IAN TREHEARNE

22 February 2021

Application ref 2020/5974/P Demolition of existing dwelling and construction of replacement dwelling with basement and associated landscaping

Figure 4 Existing rear elevations Property boundary marked in yellow.

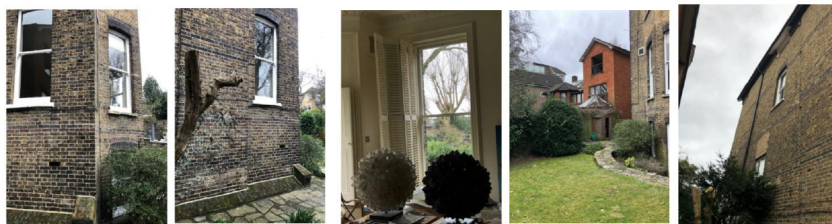
The two gardens are at approximately the same level at this point, as shown by the extract from the existing rear elevation forming part of the application at Figure 4, on which I have added the location of the property boundary in yellow.

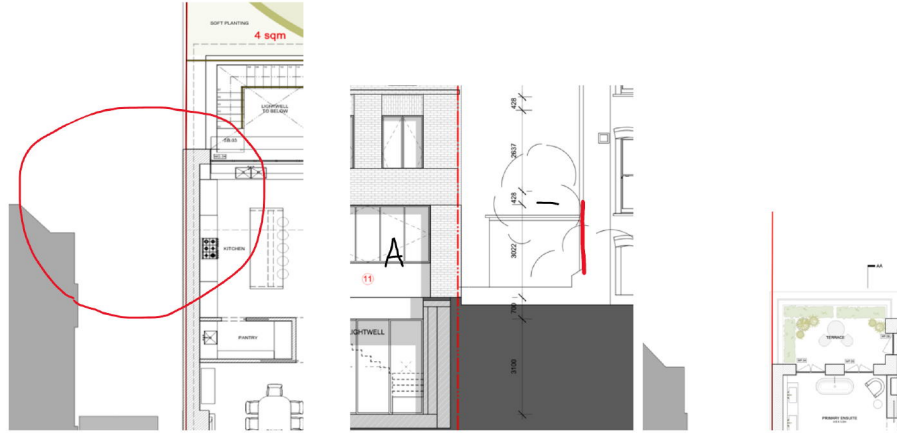
At first floor level the rear wall is cut back to align with the rear wall of no 5 with a proposed terrace at first floor level proposed adjoining the boundary and at a height of some 3.5 metres or 4 metres to the top of the parapet. These proposed features are shown on the three drawing extracts at Figure 6, below, both from the proposed plans forming part of the application.

The left-hand extract shows the relationship of the proposed rear corner of the ground floor at no 5b with the existing layout at no 5. I have drawn a red line round the relevant part.

The central extract shows the rear elevation of the proposed no 5b and the existing no 5. The proposed terrace is marked 'A', and the existing side window I marked with a red line.

The right-hand extract is a plan of the relevant area at first floor level

It will be seen that the overlooking effect of the terrace on both the garden and the window is very marked, and that there will be a clear view from it into my client's living room from a distance of less than 10 metres. There will also be significant overlooking of my client's garden.

The outlook from the side window of my client's flat will be largely obscured at a distance of about 4 metres.

It will be noted also that this relationship, both of the proposed built form and the terrace, is not shown properly on any of these drawings, in that the side window is not marked on plan or elevation, and the proposal for the terrace is masked on the elevation by the brick. In addition, the proposed boundary treatment is not specified on plan or elevation and the very necessary railings which would have to surround the lightwell and staircase in this area are not shown.
